RECORD OF PROCEEDINGS CONCORD TOWNSHIP BOARD OF TRUSTEES

Mr. Johnson stated the purpose of the meeting was for the continuation of the hearing held May 1, 2024 to consider the re-zoning application #ZC032024.

CLARKSHAW VILLAGE

TRUSTEE COMMENTS FROM MAY 1ST

Study of Existing Approved Intersections with Driveway Offsets in Concord Township

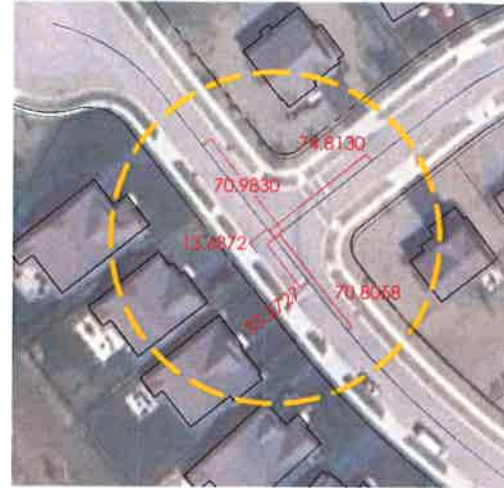
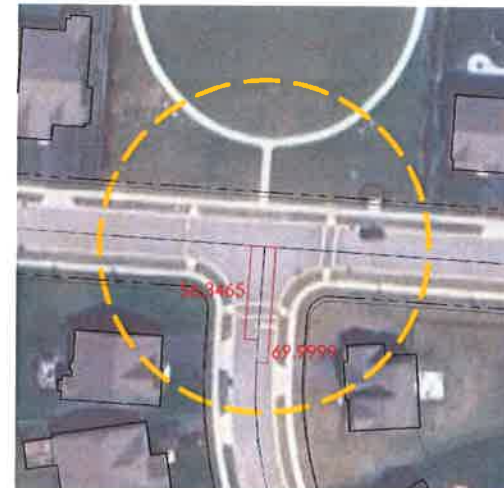
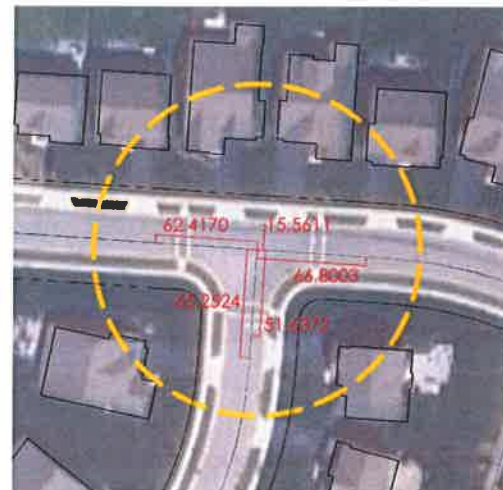
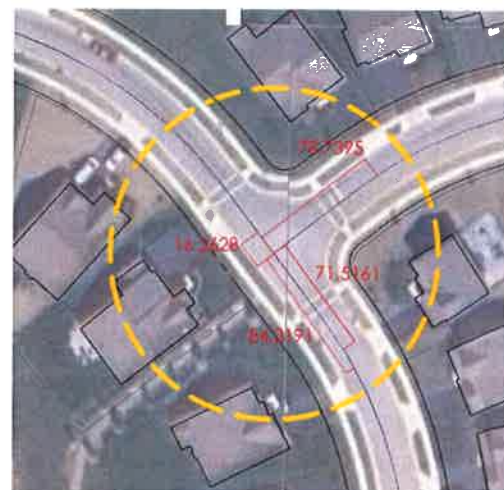
1. Fire Department Approval of Driveway Spacing for Divergence

4. Clarification on Driveway Divergence from County on any Recommended Distances to Offset.

1. We have reached out to Mr. Todd Cooper via email and phone message with no response. Emails dated 4.22.24 & 5.9.24. A text was received from Mr. Cooper on 5-15-24 that states that he does not support the divergence.

4. William Ferguson from the Delaware County Engineers Department has confirmed that the County does not have a specific requirement for distances off an intersection, and has no issues with the proposed standards, see email attached. Also, refer to previous approved intersection and setback for driveways in Clarkshaw Meadows, Clarkshaw Moors, Heather Ridge and others, attached.

EXHIBIT C-3

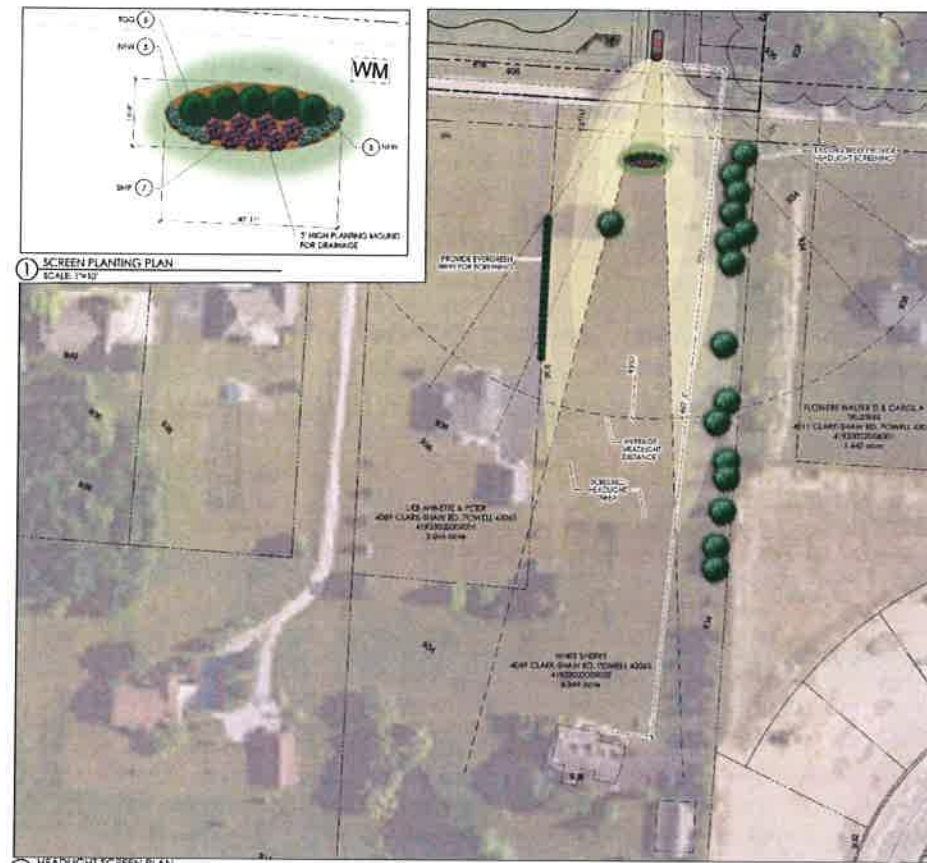
2. Confirm Pathway Widths and Materials.
3. Lot 72 Relocated to West.

2. Clarkshaw Village will develop asphalt multi-use paths 10' wide at existing R.O.W. of Clark-shaw Rd and Bean-Oller Rd. and 5' wide asphalt/concrete interior pathways. This has been added to the development text, (Section 11.07 f) Development Standards Multi Use Paths.
3. Lot 72 has been relocated to the west on Proposed Roadway 'B', and all plans reflect the new location. The divergence has been modified in the development text.

EXHIBIT D-4.11

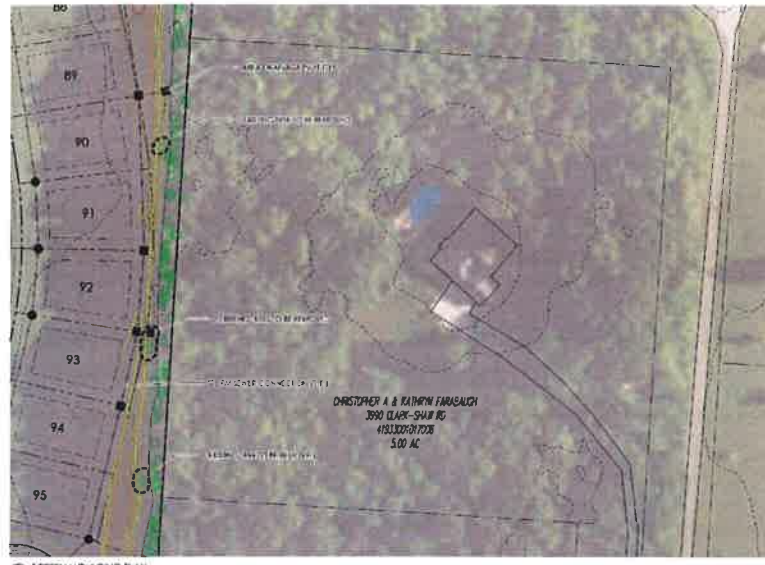
5. Screening for headlights for properties east and west of entry at Clark-Shaw - discuss and address with those residents. Lieb, Annette & Peter, 4089 Clark-shaw Rd, Flowers, Walter & Carol, 4011 Clark-shaw rd.

Additional screening exhibits have been presented and accepted by the concerned property owners. Refer to updated exhibits Tab 4, D-4.11

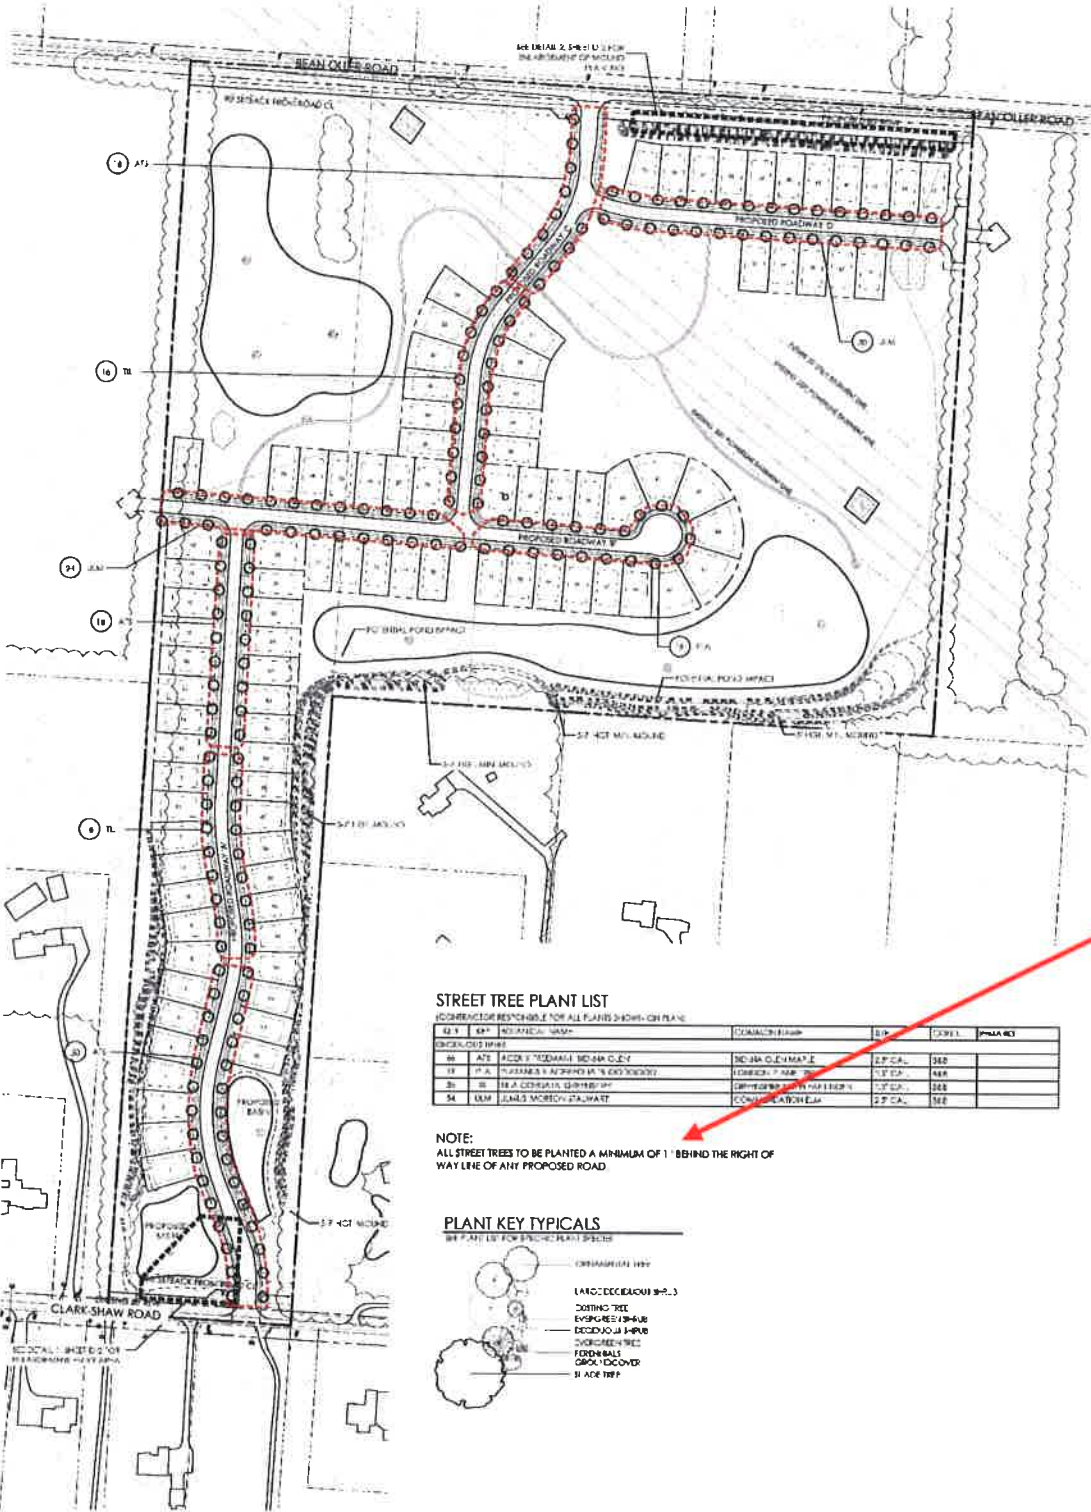
9. Turn lane on Clark-shaw - get county engineers statement/opinion (township desires turn lane) Pre Engineer:

10. Letter from county in regard to traffic study- is date of study too old, why 50% distribution north and south entries- (township doesn't agree)

- We ran the numbers and the right hand turn lane is not warranted regardless the number of trips this development uses Clarkshaw.
 1. The site would need 600-700 units to trigger a right hand turnlane.
 2. A right-hand turnlane would be 225 ft total length and extend east of the existing driveway. The ditch improvements will relocate the existing fence and probably remove the large tree next to the driveway.

- We talked to the County and Chris Bauserman has had multiple conversations with one or more of the Township Trustees.
- The County's official statement is they have reviewed the TIS for the project and agree with the basis of the study.
- We ran a scenario with different splits of traffic north and south (TIS has 50/50 split) and it does not change the results of the study.
 - Any scenario will require a left TL on Bean Oller and no TL warranted on Clarkshaw.
- The traffic counts used in the TIS are from 2022 and we used an annual growth rate of 5% (MORPC is using 3% or less).
 - We received 2024 traffic counts from the County on Bean Oller and compared them to what was used in the TIS and the counts are very close and within an acceptable range for a study.
